Access Compliance Report

Public Rights-of-Way

Intersection ID: 46788	Main Street: STOWE_ACRES_DR	Cross Street: ALMOND_HILLS_DR	Location: SE
ADA ID: 4A2C83D97E23	Ramp Type: PerpDiag	Initial Pass/Fail: Fail	Overall Compliance: No
Severity Score: 22.5			
Codes/Mitigation Info/Possible Solution		Field Measurements/Component Compliance

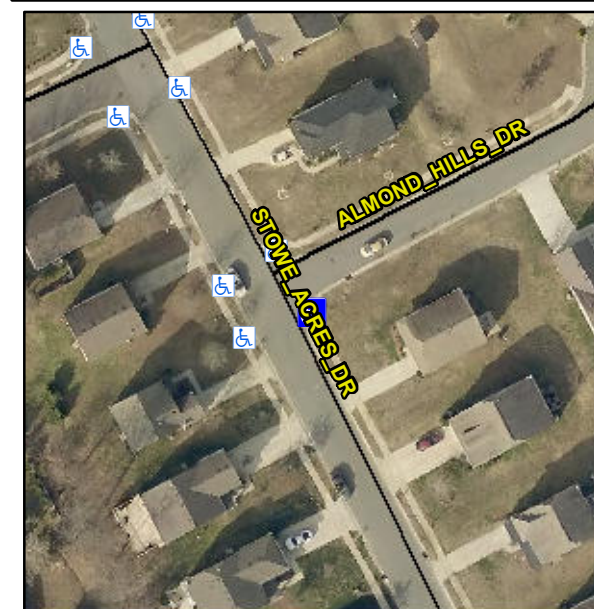
Not Found, R304.5.1, R304.2.2, R304.5.3

Compliance	Description	Data	Compliance	Description	Data
N/A	Ramp Length (in)	46.5	No	Ramp Slope (%)	9.0
No	Ramp Width (in)	36.0	No	Ramp XSlope (%)	3.2
N/A	Flare Type LT	N/A	N/A	Flare Type RT	N/A
N/A	Flare Slope LT (%)	N/A	N/A	Flare Slope RT (%)	N/A
N/A	Flare Traversable LT?	N/A	N/A	Flare Traversable RT?	N/A
N/A	Landing Length (in)	N/A	N/A	DWS Provided?	N/A
N/A	Landing Width (in)	N/A	N/A	DWS Contrast?	N/A
N/A	Landing Slope (%)	N/A	N/A	DWS Length (in)	N/A
N/A	Landing X Slope (%)	N/A	N/A	DWS Full Width?	N/A
N/A	Landing Curb? (Y/N)	N/A	N/A	DWS Offset (in)	N/A
N/A	Shared Landing?	N/A			
N/A	Gutter Ponding?	N/A	N/A	Gutter Slope (%)	N/A
N/A	Gutter Lip Ht (in)	N/A	N/A	Gutter X Slope (%)	N/A
N/A	Painted X Walk1?	No	N/A	Painted X Walk2?	No
	X Walk 1 Direction	To N		X Walk 2 Direction	To W
N/A	X Walk 1 Width (in)	N/A	N/A	X Walk 2 Width (in)	N/A
	X Walk 1 Slope (%)	3.2		X Walk 2 Slope (%)	0.4
	X Walk 1 X Slope (%)	1.2		X Walk 2 X Slope (%)	2.6

Remove & Replace Curb Ramp With Two New Directional Ramps or Equivalent.
